ACP-2017-079
SHETLAND SPACE CENTRE LIMITED (SAXAVORD
SPACEPORT) AIRSPACE CHANGE PROPOSAL
CAP1616 STAGE 4B SUBMISSION

AIRSPACE DESIGN UPDATE
(Design Option 3.2)

AVISU Reference	ACP_2017_079_Stage_4_Design_Update_3_Nov_23_V1_0_FINAL
------------------------	--

Figure 1 - ACP-2017-079 Design Option 3.2 (With Updated Internal Segmentation)

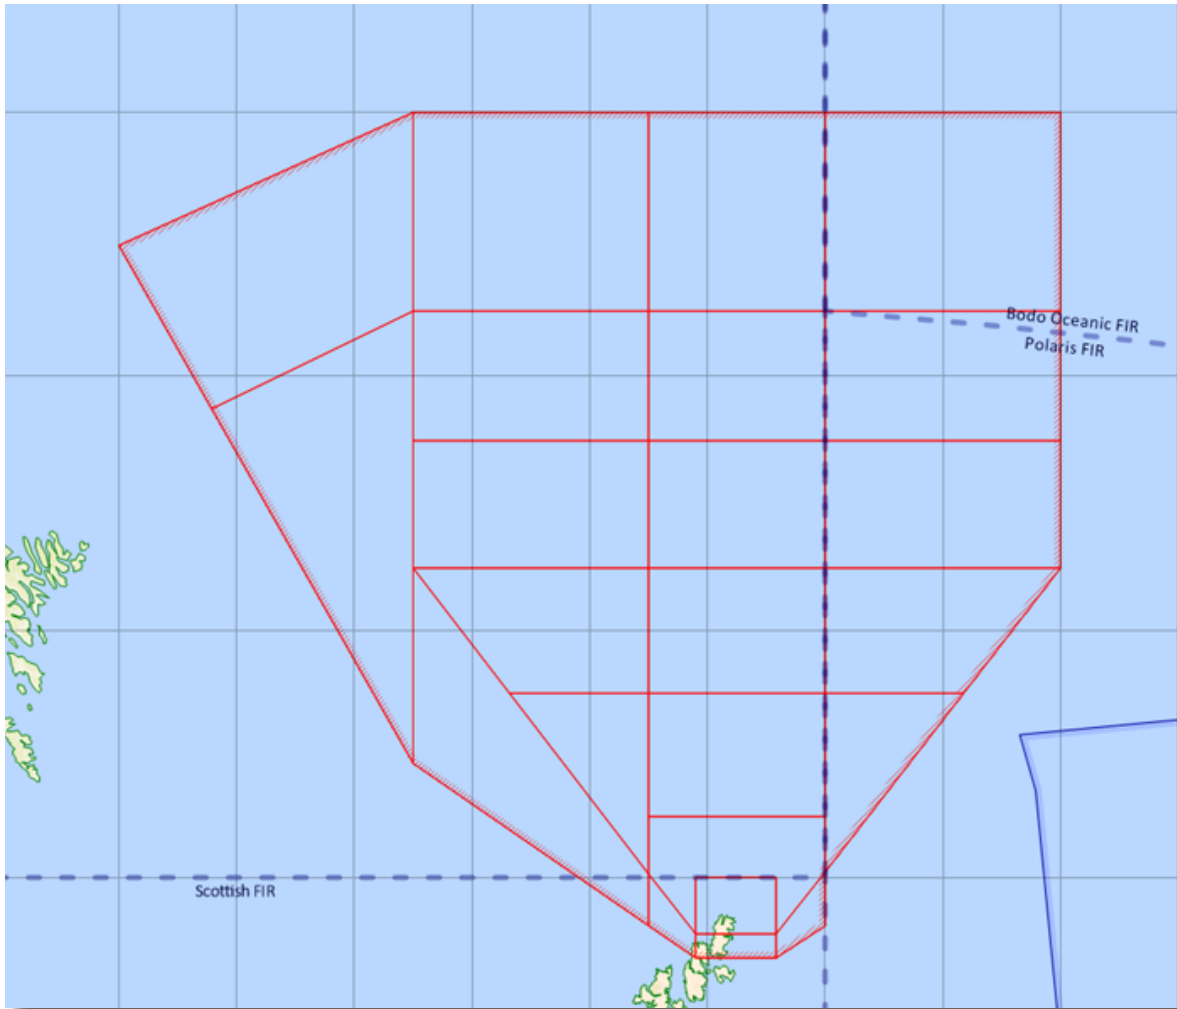
The internal structure (i.e. segmentation) of the proposed design has been further rationalised and the individual elements therein renamed to meet the CAA’s “identification convention”.⁴ Consequently:

- The number of internal segments (“sub-parts”) has been reduced, thereby offering an internal structuring that is simpler to interpret while maintaining sufficient operational flexibility.
- The updated structure does not change any of the impacts on stakeholders and no update beyond that contained in the Stage 4 Addendum is considered necessary.

Figure 1, below, indicates the proposed updated design option, Design Option 3.2, incorporating the updated internal segmentation.

Figure 2 - ACP-2017-079 Design Option 3.2 (With Updated Segmentation Nomenclature)

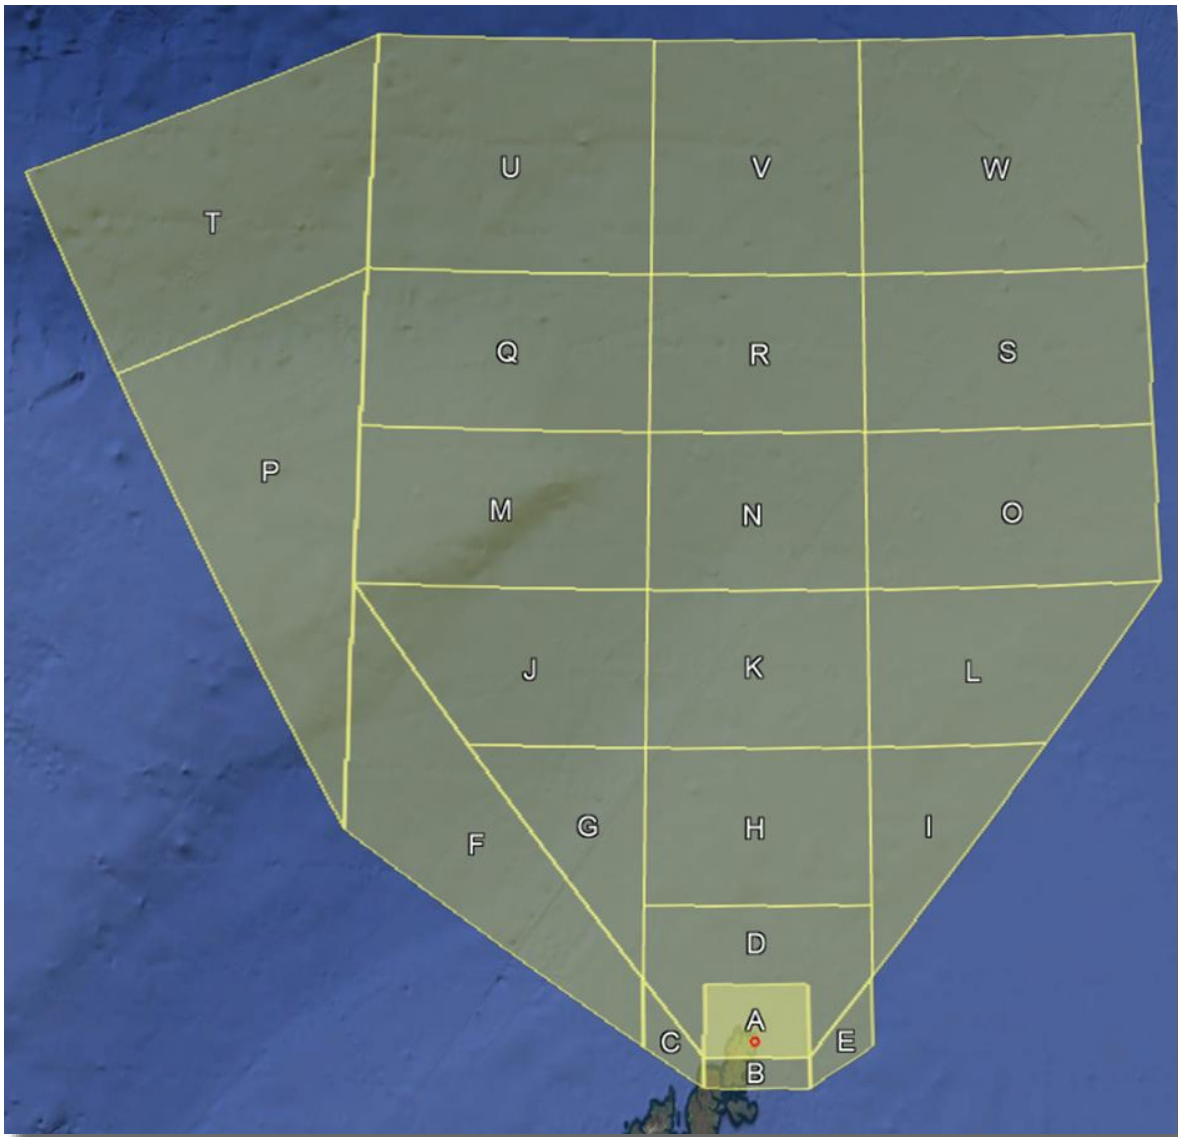
Additionally, the previous “box” and “wedge” descriptors have been replaced by the requisite (and more familiar) lettering convention.

Figure 2, below, indicates the proposed updated design option, Design Option 3.2, with internal segmentation nomenclature.
